# Access Compliance Report

## Public Rights-of-Way

### (Curb Ramps)

Intersection ID: N/A	Main Street: PERWINKLE_HILL_CT	Cross Street: N/A	Location: E
ADA ID: 5603DF3808D6	Ramp Type: PerpDiag	Initial Pass/Fail: Pass	Overall Compliance: No
Severity Score: 15.25			
Codes/Mitigation Info/Possible Solution		Field Measurements/Component Compliance

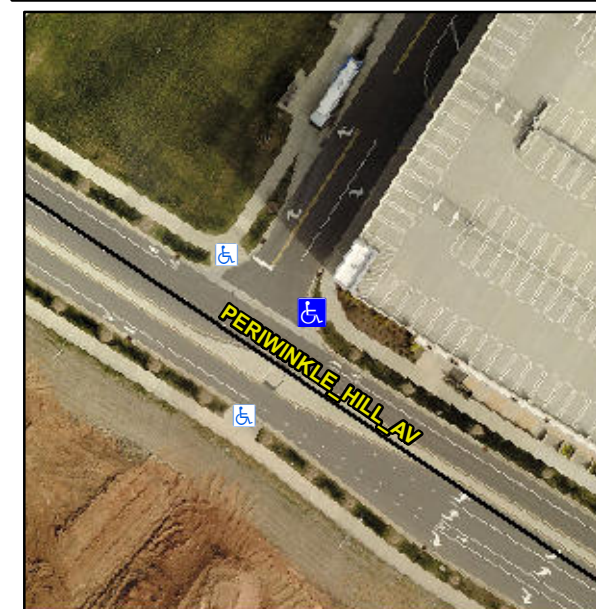
**Not Found, R304.5.3, R304.2.1, R304.2.2-Perp, R304.3.2-Para, R302.7.2**

Compliance	Description	Data	Compliance	Description	Data
N/A	Ramp Length (in)	92.0	Yes	Ramp Slope (%)	8.1
Yes	Ramp Width (in)	49.5	No	Ramp XSlope (%)	2.6
N/A	Flare Type LT	Sloped	N/A	Flare Type RT	N/A
N/A	Flare Slope LT (%)	2.5	N/A	Flare Slope RT (%)	7.1
N/A	Flare Traversable LT?	No	N/A	Flare Traversable RT?	No
Yes	Landing Length (in)	96.0	Yes	DWS Provided?	Yes
No	Landing Width (in)	47.0	Yes	DWS Contrast?	Yes
No	Landing Slope (%)	2.6	Yes	DWS Length (in)	24.0
No	Landing X Slope (%)	2.2	Yes	DWS Full Width?	Yes
N/A	Landing Curb? (Y/N)	No	Yes	DWS Offset (in)	0.0
N/A	Shared Landing?	No			
Yes	Gutter Ponding?	No	Yes	Gutter Slope (%)	1.5
No	Gutter Lip Ht (in)	1.5	No	Gutter X Slope (%)	4.9
N/A	Painted X Walk1?	No	N/A	Painted X Walk2?	No
	X Walk 1 Direction	To NW		X Walk 2 Direction	To SW
N/A	X Walk 1 Width (in)	N/A	N/A	X Walk 2 Width (in)	N/A
	X Walk 1 Slope (%)	1.8		X Walk 2 Slope (%)	3.5
	X Walk 1 X Slope (%)	4.0		X Walk 2 X Slope (%)	3.6

N/A	Ramp inside XWalk1?	N/A	N/A	Ramp inside XWalk2?	N/A
	Road Slope (%)	4.5	N/A	Clear Space?	Yes
	Road X Slope (%)	0.7	N/A	Clear Space to XWalk (in)	N/A
Yes	Any Obstructions?	No	Yes	Storm Grate/Utility Hazard?	No
	Obstruction Type			Storm Grate/Utility Type	
		N/A			N/A
			Yes	Surface Condition? (G/P)	Good

**Remove & Replace Curb Ramp With Two New Directional Ramps or Equivalent. Remove & Replace Gutter.**
